From: "Richard Kahn" <rakahn@sbcglobal.net>
To: "Eric Jameson" <EJameson@dnr.state.ga.us>
Date: Thursday, 31 August, 2006 17:58:39
Subject: Addition of a new shielding design to our registry

DOSE RATE MAP – CNA Gen III-S "(Small)"

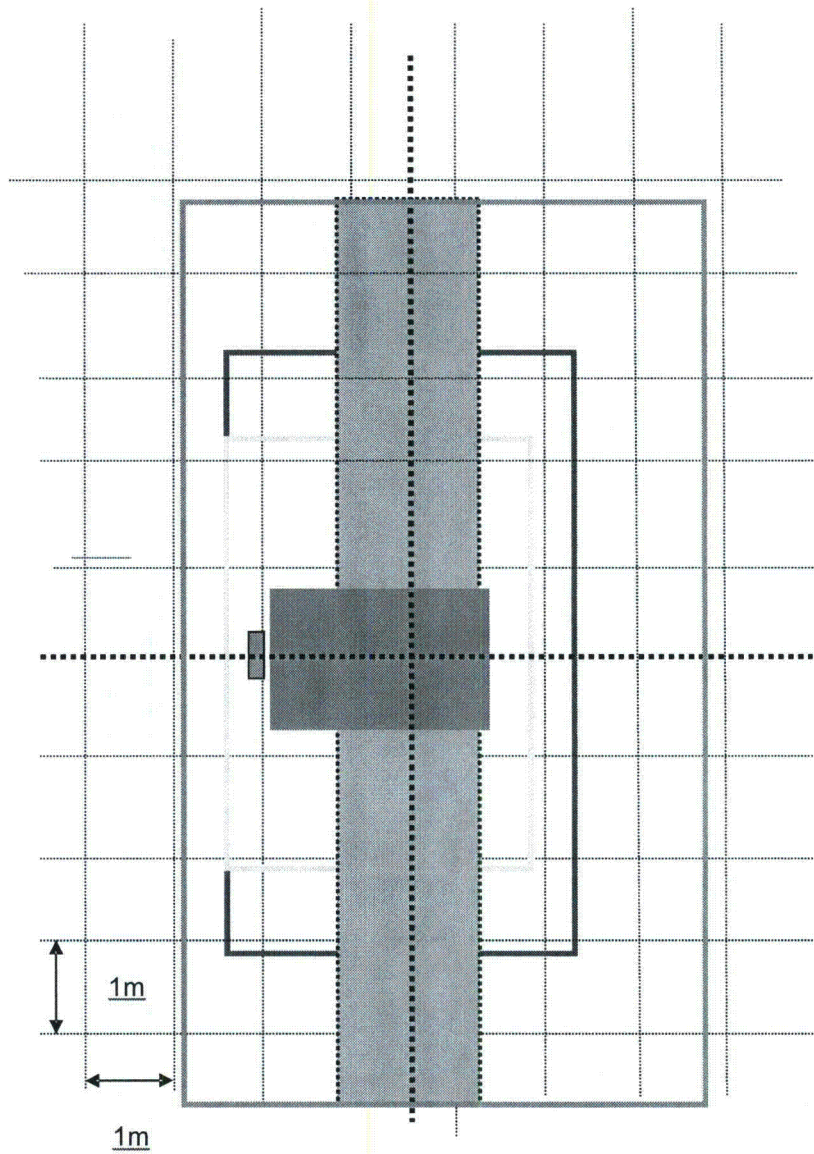
As we discussed last week, we would like to amend our registry to include a new shielding version of our CNA. The analyzer is virtually identical functionally with the same measuring chamber. The biggest difference is that with this unit the end user will need limit access around the unit when it is operating (a radiation survey is attached following the drawing). We include a safety interlock with the unit that will immediately shut down the neutron emissions to zero when the restricted area is accessed. ★

Conveyor Belt	Inaccessible area during CNA operation
	Perimeter A	< 2.5 mrem/h
	Perimeter B	< 0.75 mrem/h
	Perimeter P	< 0.25 mrem/h
